SERVICE NOTES
For the receiver

BX 388 A/U

N.Y. PHILIPS' GLOEILAMPENFABRIEKEN EINDHOVEN	Drive in the radio sets BX 388 A/U	R.S. 917
SERVICE	15.4.49

fig1

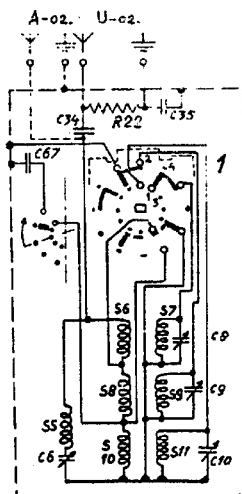
For data, which are not mentioned here is referred to the notes for the receivers BX 388 A or BX 388 U.
The only difference is a Foreign-Local switch, consisting out of:

- a. Switch A3 181 40.0
- b. Two grommets 23 652 17.0
- c. C67, 4700 pF 48 751 20/4K7.

For details see the figures 1, 2 and 3.

fig. 4.

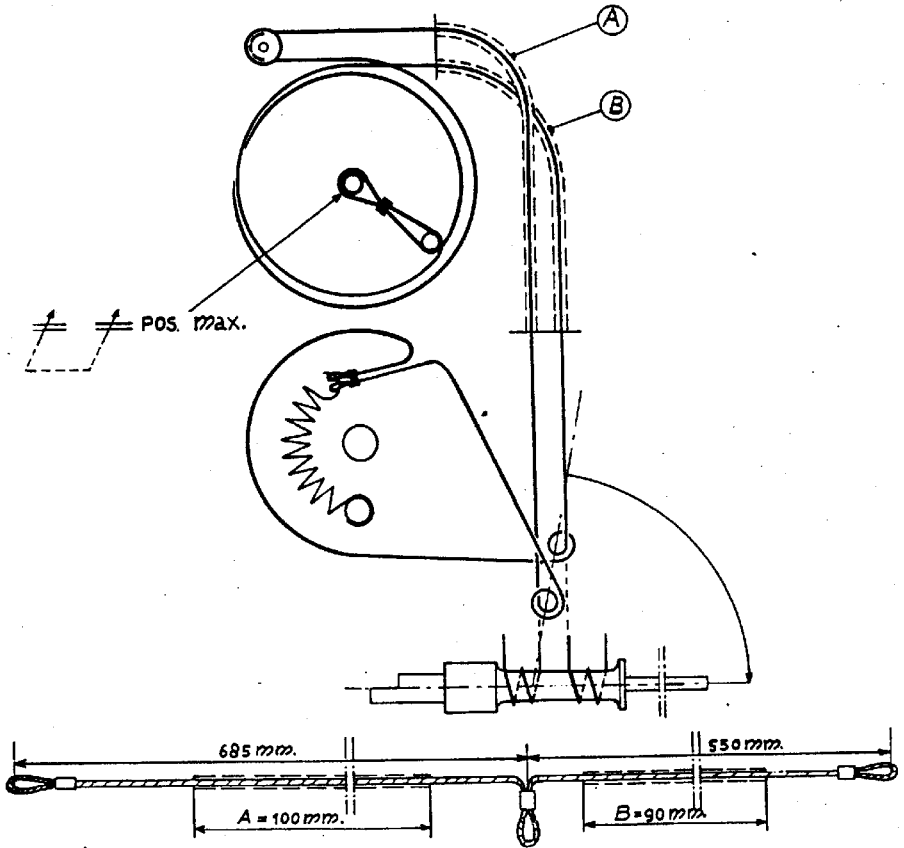
After this has been done make the driving core the right length. The cord loop is shown in fig. 4. When mounting the variable condenser set is to maximum capacity (turned clockwise). Take care that the cord is laid exactly shown in the illustration.

In later series, as already stated, this alteration has already been made. The cord is shorter because the driving drum on the spindle of the variable condenser is turned 180°. The length of cord for these sets are 536 and 482 mm. The outer cable A is again passed over the longest cord (see fig. 4).
